City of Appleton Application for Variance

Variance Information
Municipal Code Section(s) Project Does not Comply 23-46(9)(5) - 35' rear yard setback.
Brief Description of Proposed Project Construction of a deck spanning 2 townhouse style units, over a planned drainage system. 26'8" from rear lot line.

RE: Variance Application for 2911 N. Drew St. (31-6-3216-00)

deck location site
plan

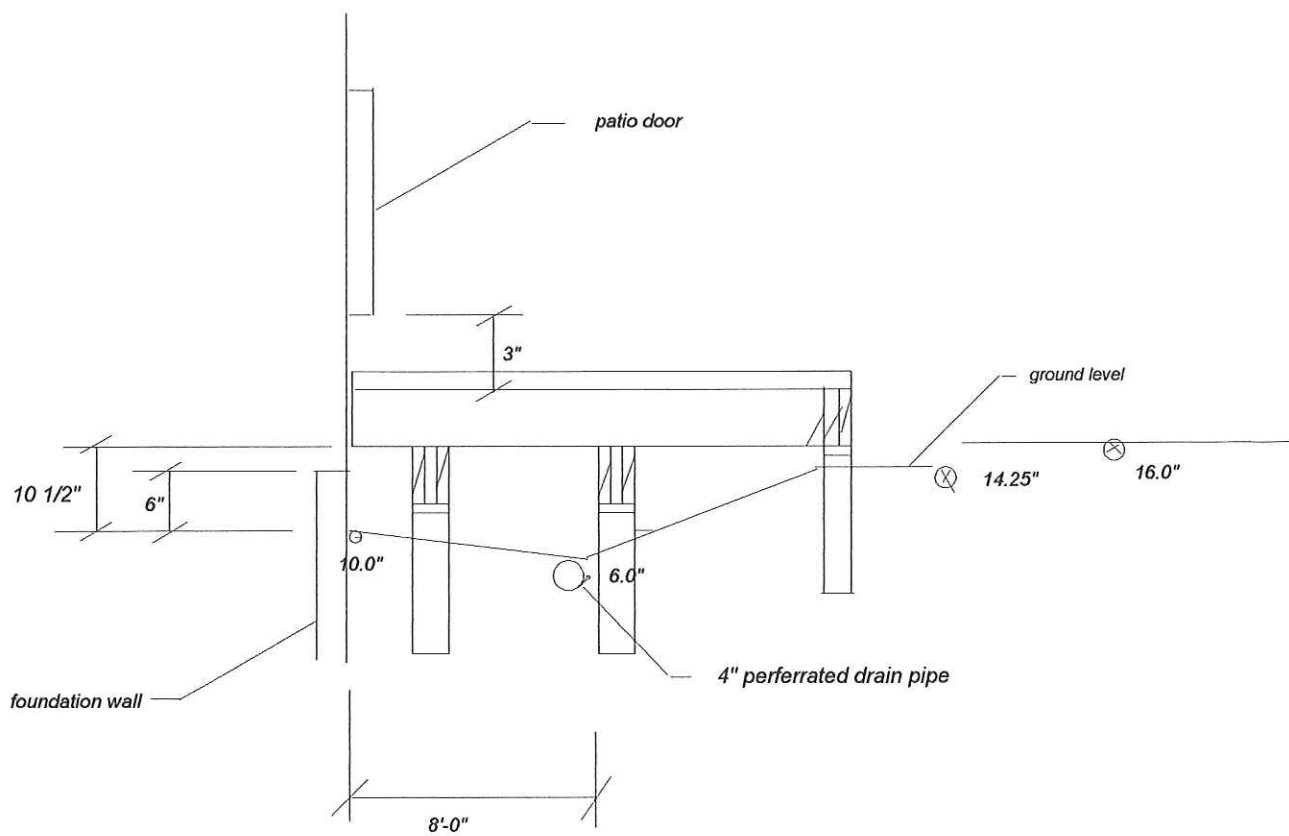
The applicant states in the application that the rear yard has significant water issues that have affected the foundation of the building. However, the question that needs to be addressed is why the deck needs to be 26' 8" from rear lot line? It appears that a smaller deck could still satisfy the applicant's need to cover up trenches for draining.

The applicant has not met the hardship criteria for a variance because a smaller deck is an alternative and the applicant has not shown that building a deck closer than 35 feet from the rear lot is essential for the use of the property.
